SOLICITATION ADDENDUM NO. 2

Project Title	Date Prepared	Project No.
SJCCD Maritime Expansion Fire Training Center	December 4, 2019	CSP 20-12

ADDENDUM NO. 02

Project: **Maritime Expansion Fire Training Center**
 San Jacinto Community College District

WALL SECTIONS
 AND PARTITIONS

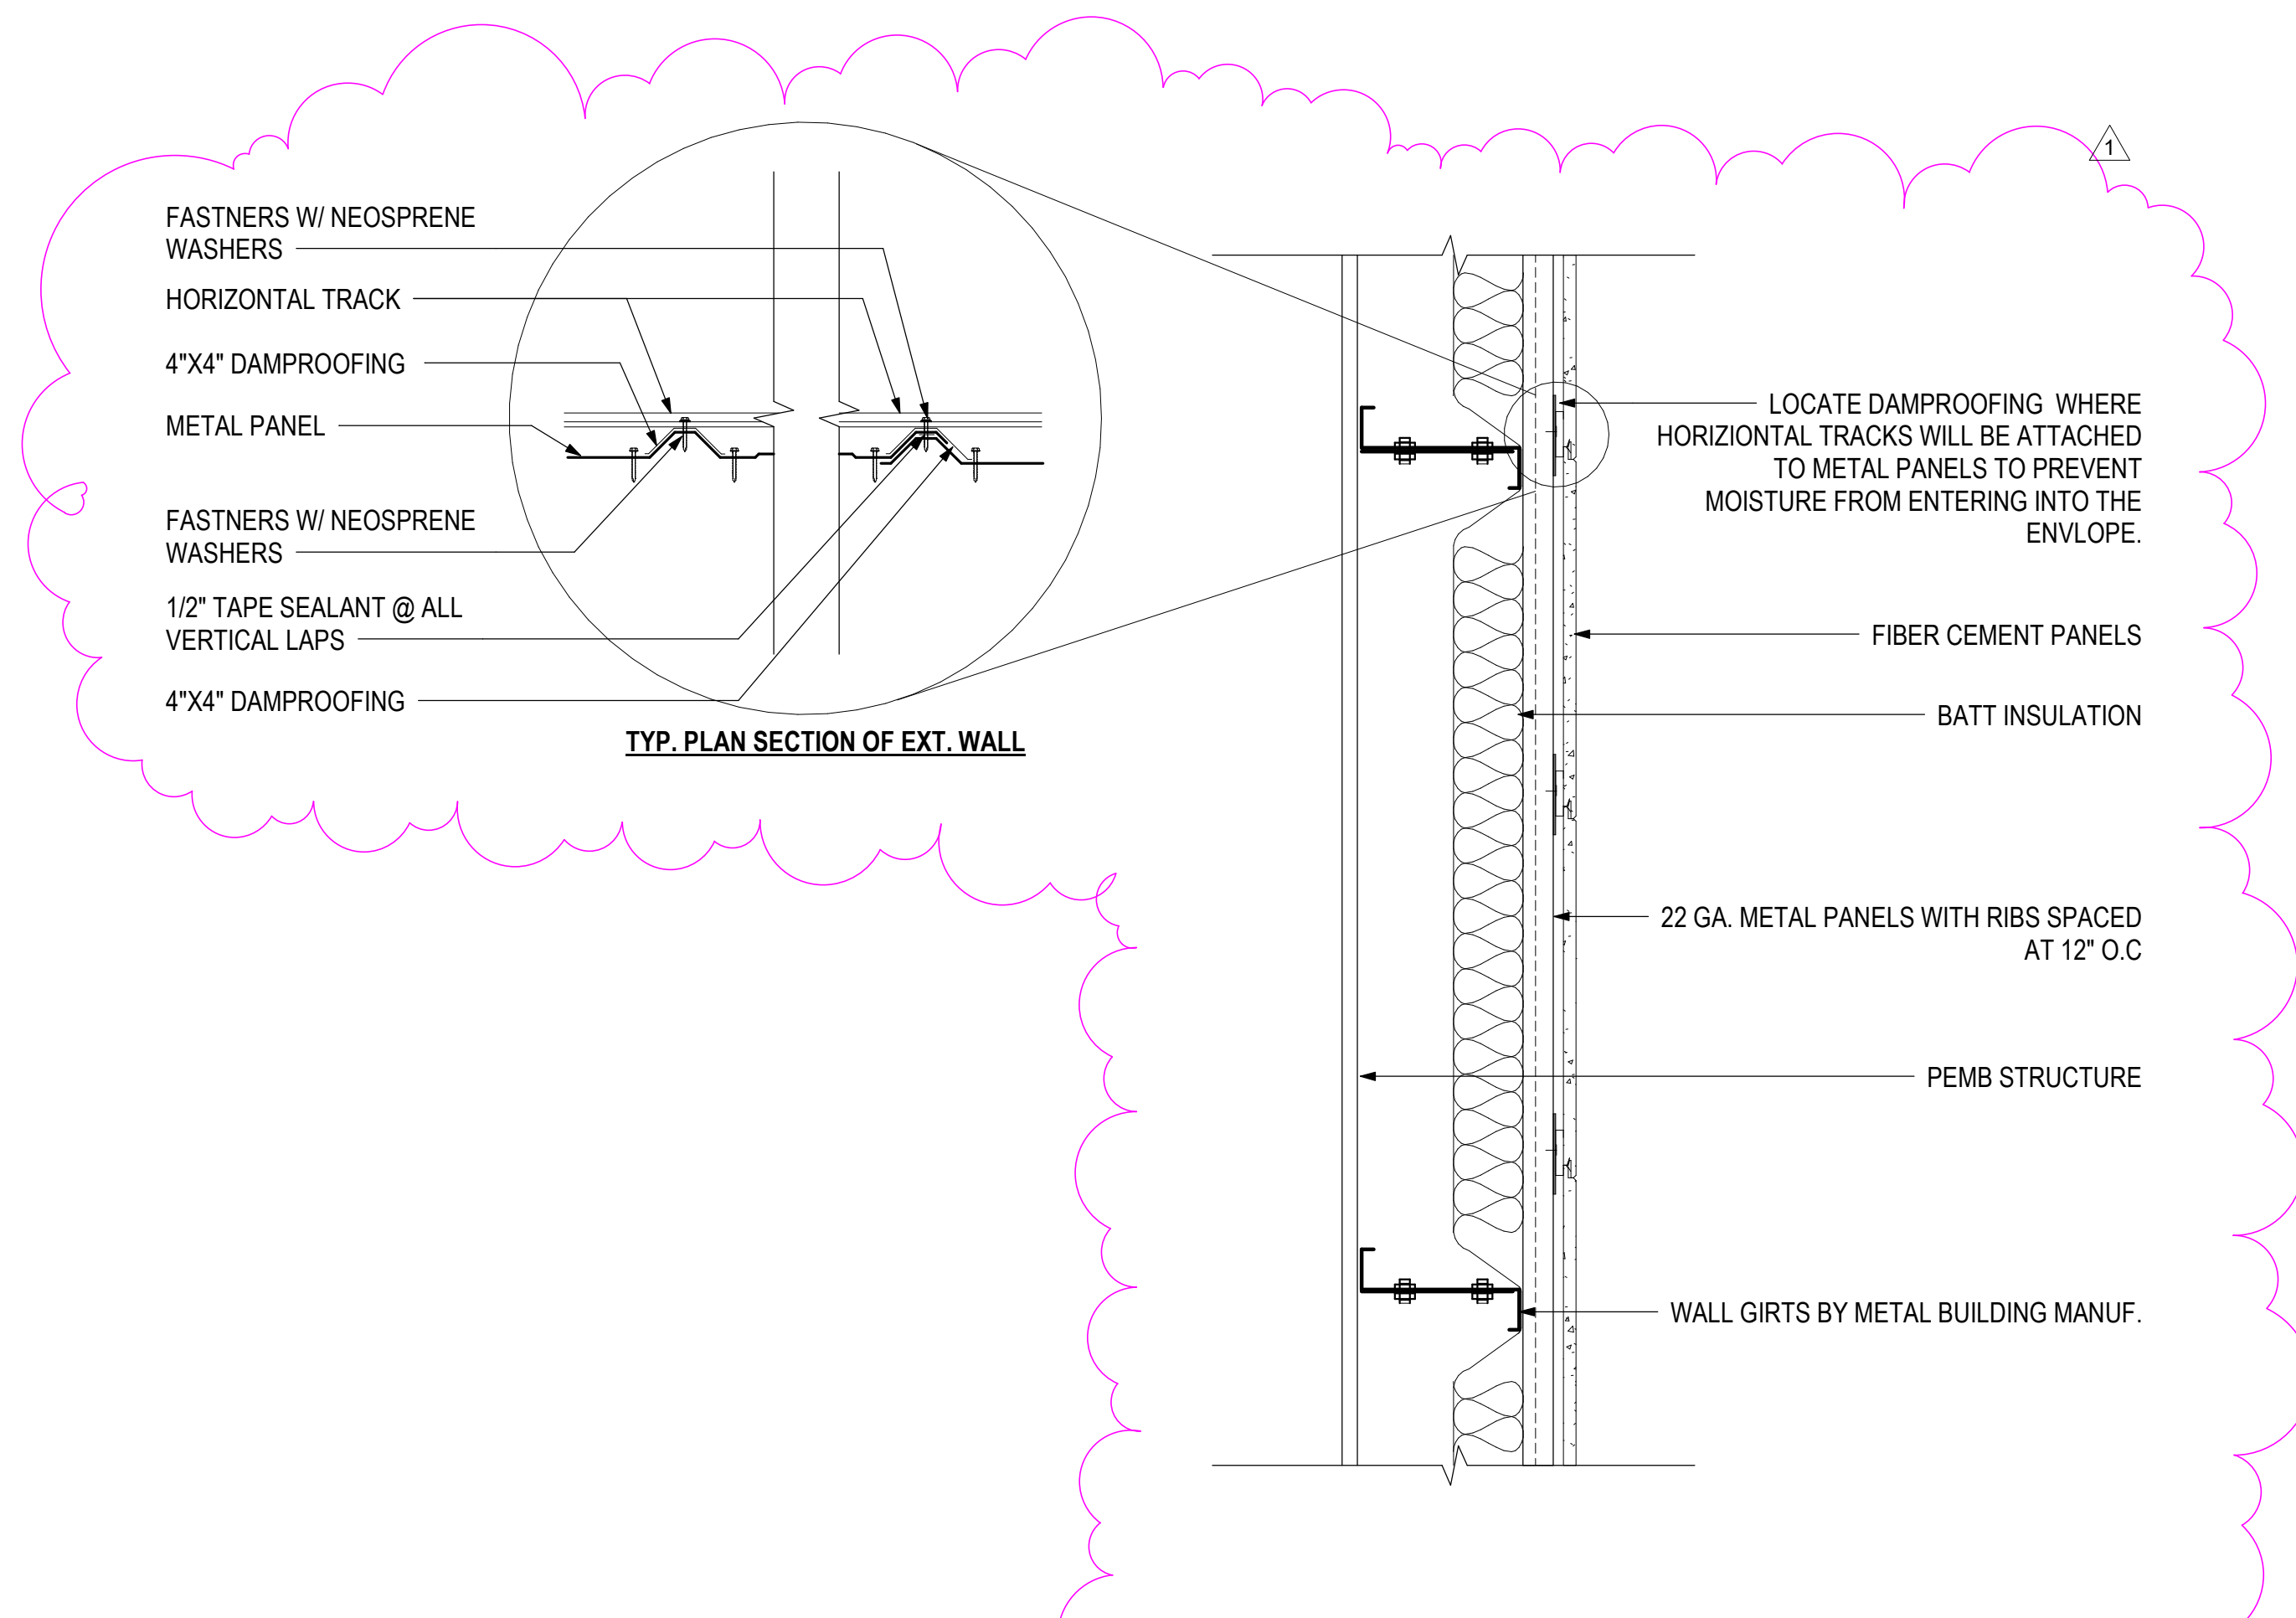
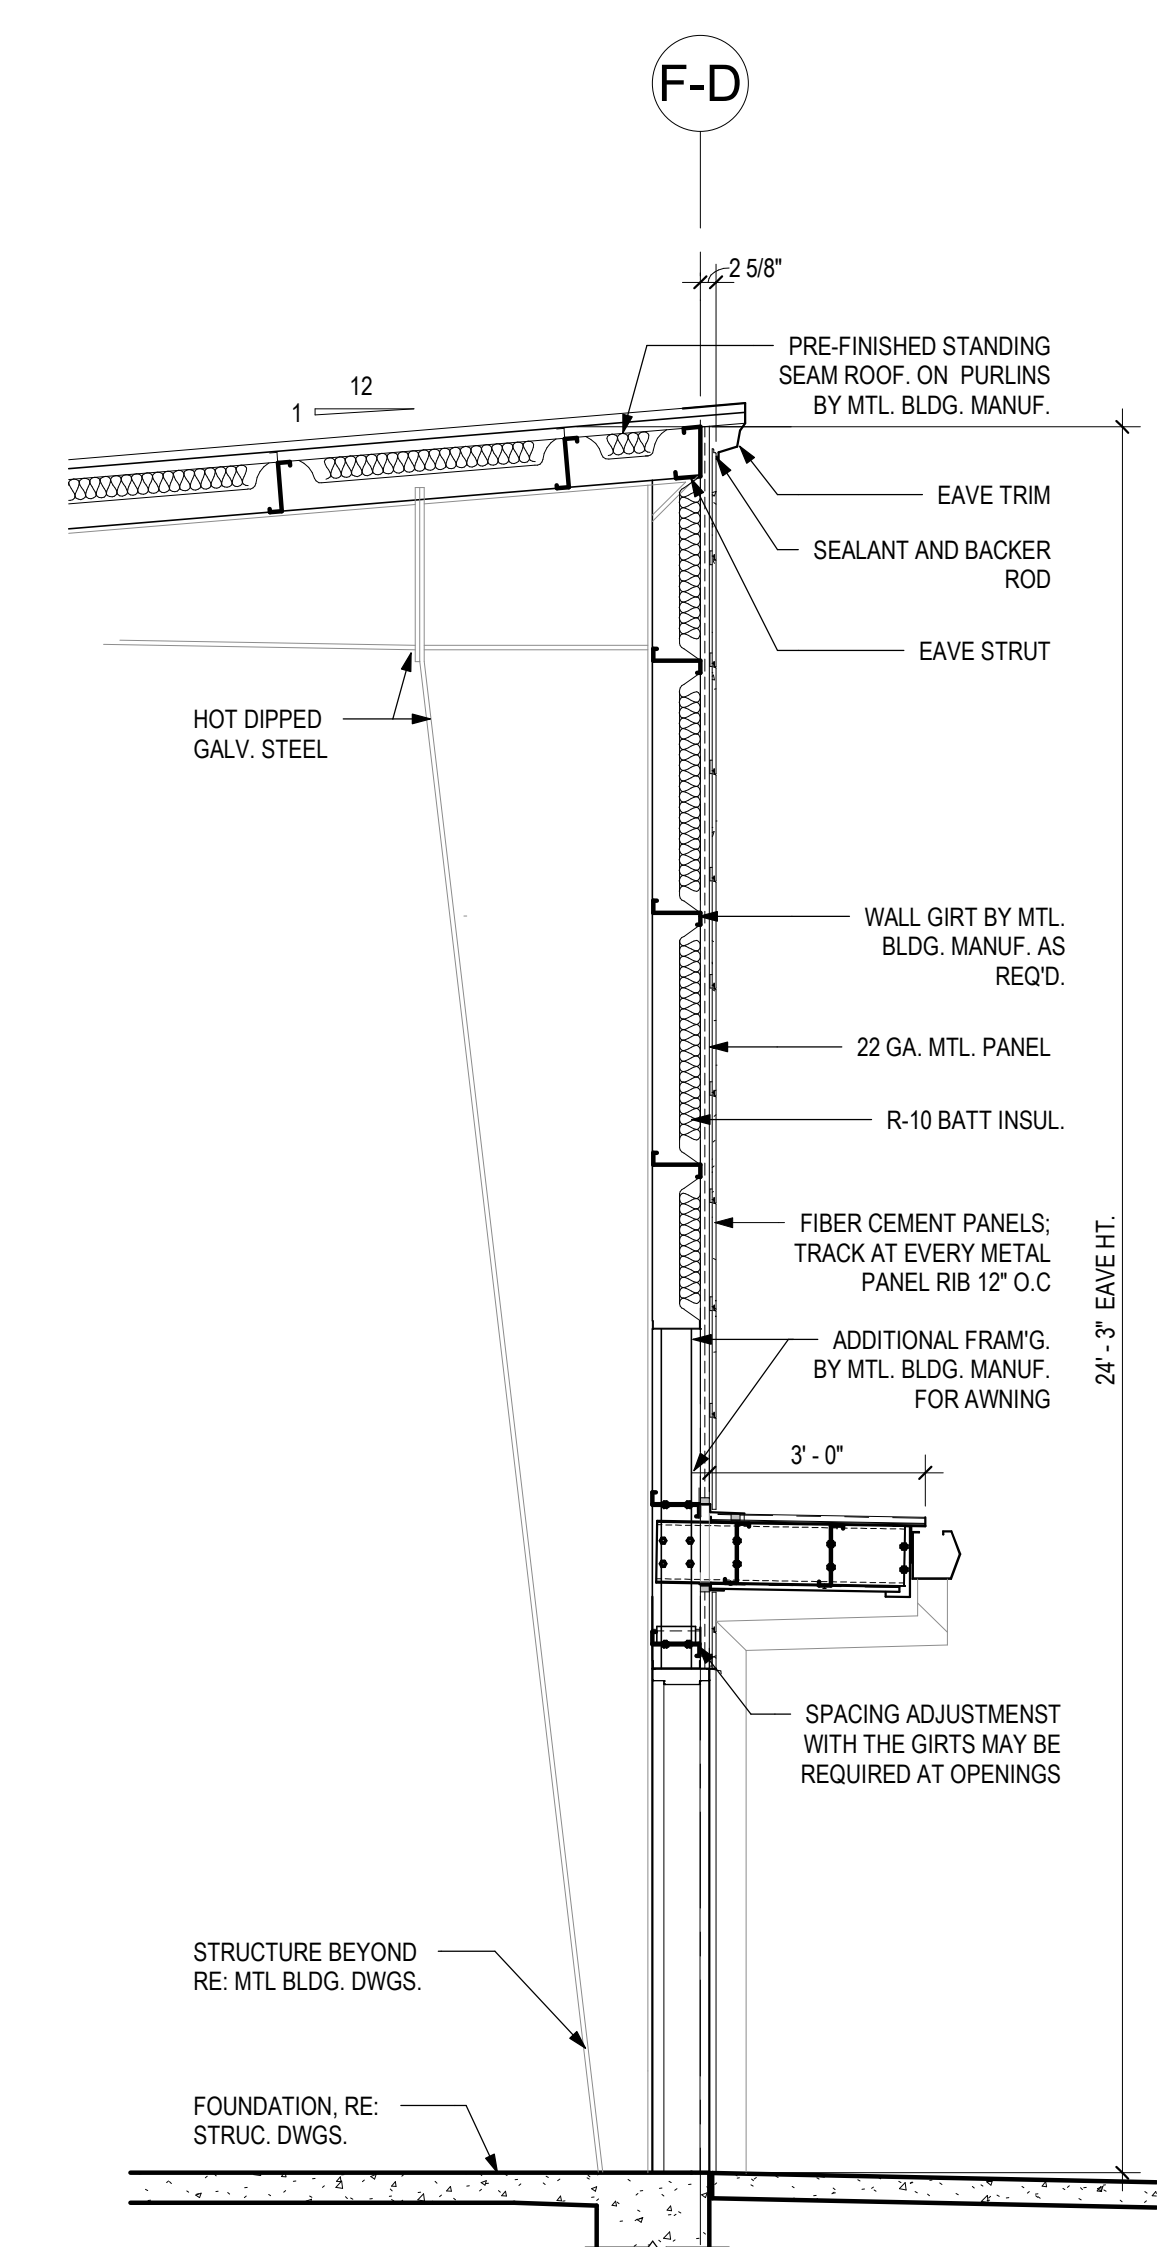
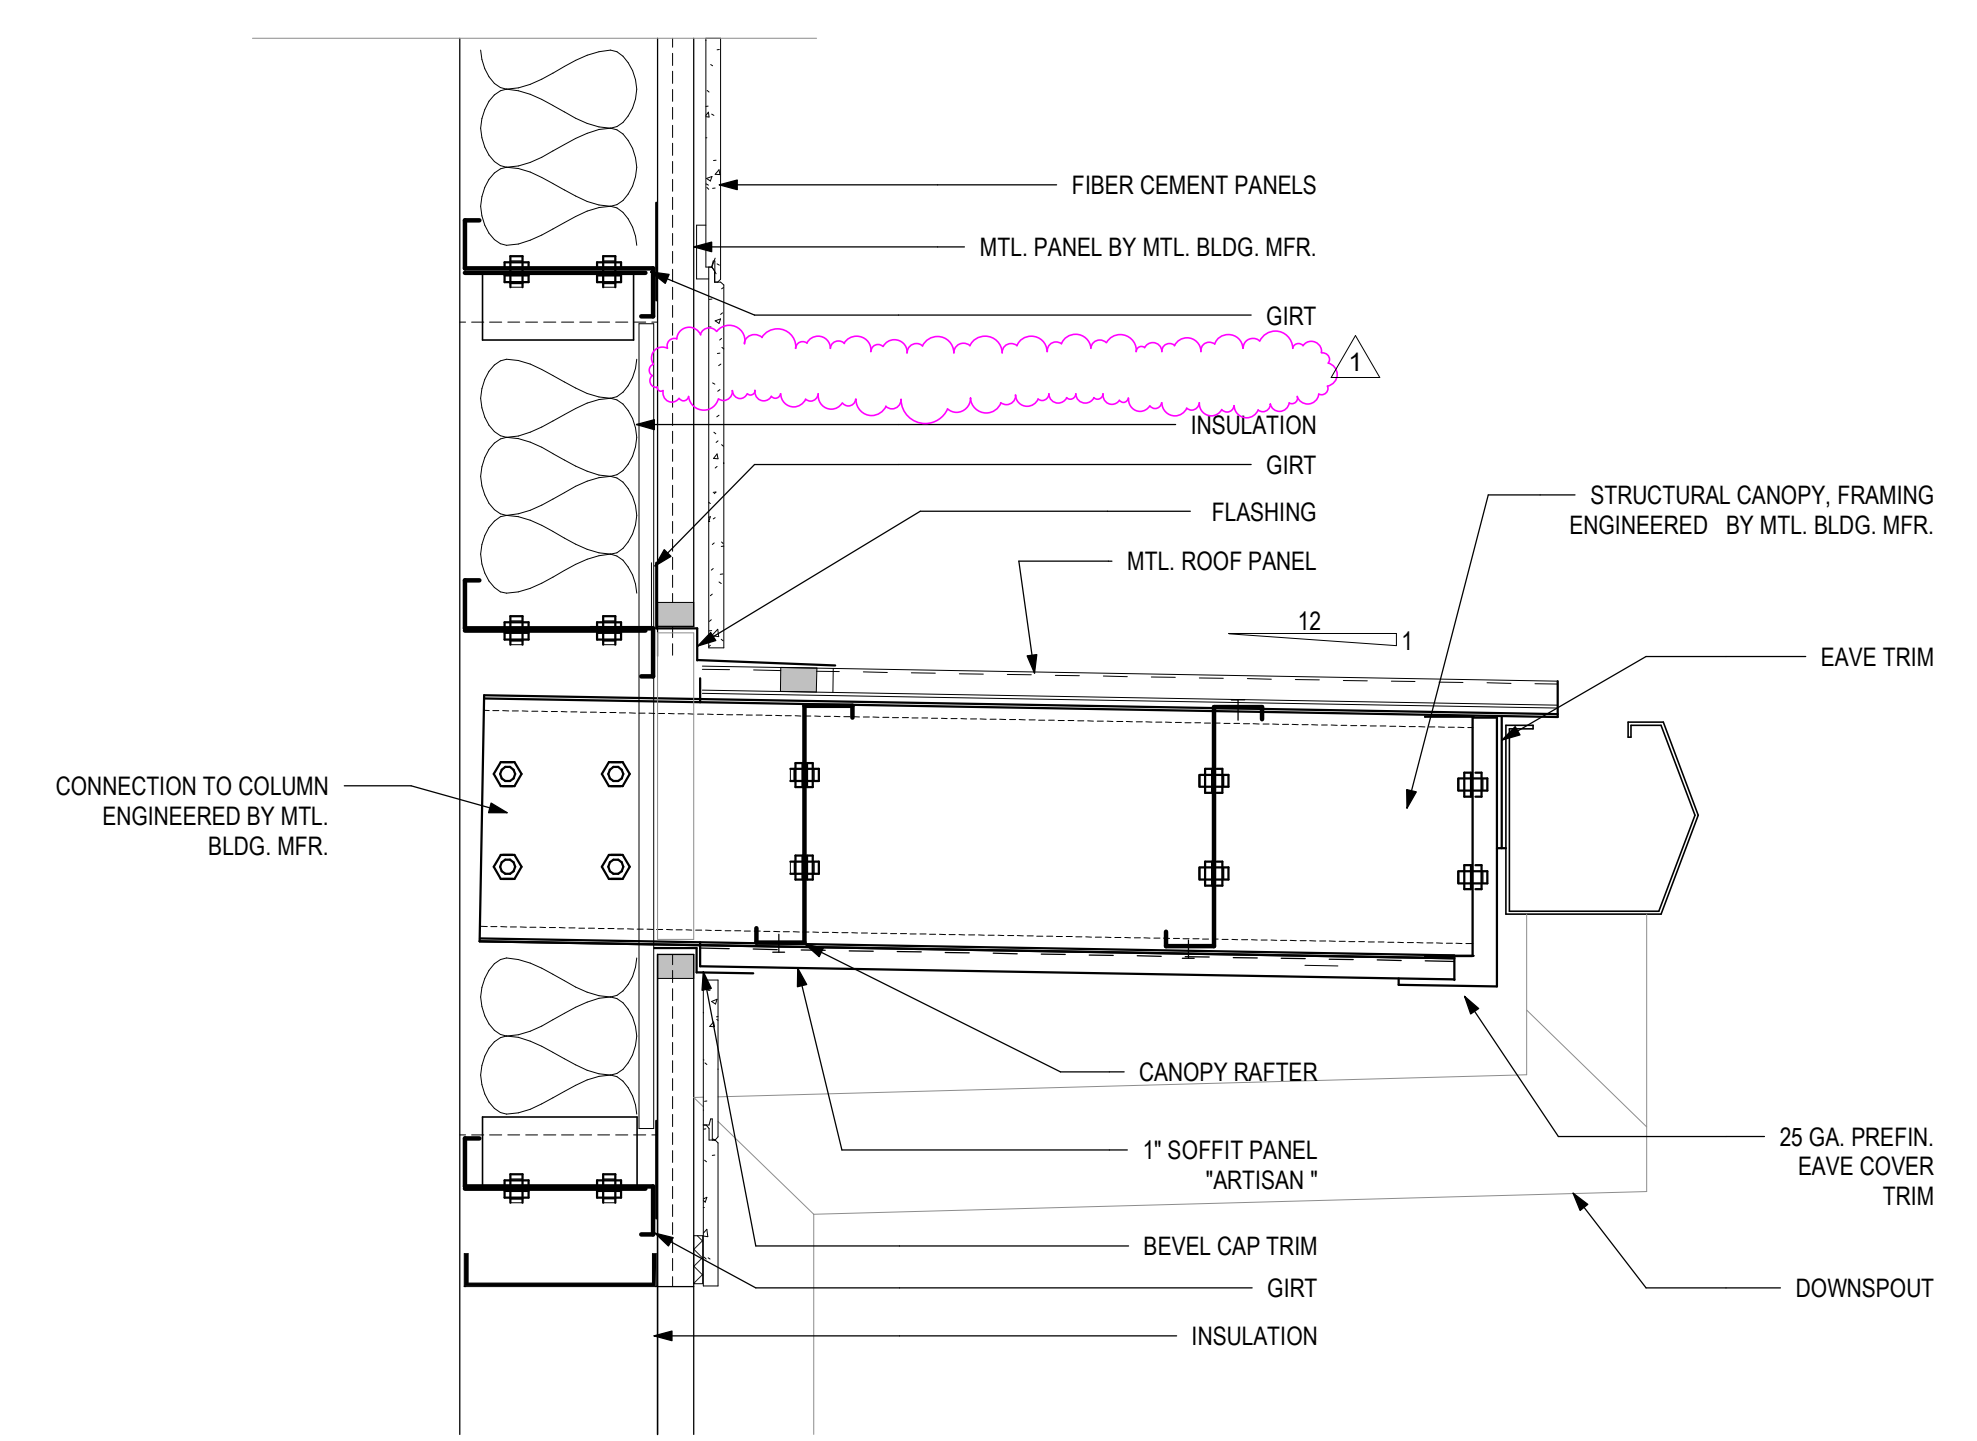
19. Sheet A6.00 – Wall Sections and Partitions
 - a. The structure below the mezzanine has been revised to state “Hot Dipped Galvanized Steel”.
 - b. On detail 7, “SHEETING” has been removed from the detail.

- c. Detail 8, an enlarged wall section detail has been added to the sheet
